# PUBLIC NOTICE CITY OF BEXLEY ARCHITECTURAL REVIEW BOARD BOARD OF ZONING AND PLANNING

a. Application No.: BZAP-20-6Applicant: Brian Marzich

Location: 796 S. Remington

**BZAP-20-6**

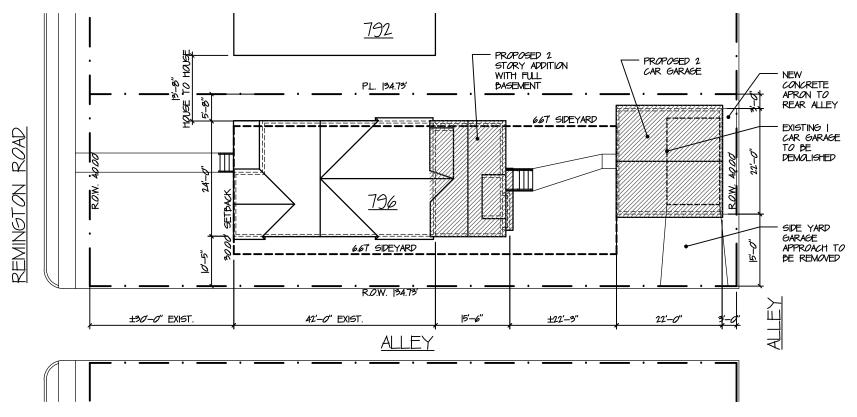
There is a section of the house on the site plan that appears to be closer to the north property line than the proposed addition. Can you tell me if that is the case and what the distance is if it is. It could also just be referencing the soffit, so I thought I'd ask. Thanks! **Brian Marzich** March 10th 2020, 1:06:52 pm

Kathy. That is the existing eve that projects a bit further than the rakes. The new addition north wall will align with existing as to not encroach further than existing. Thanks
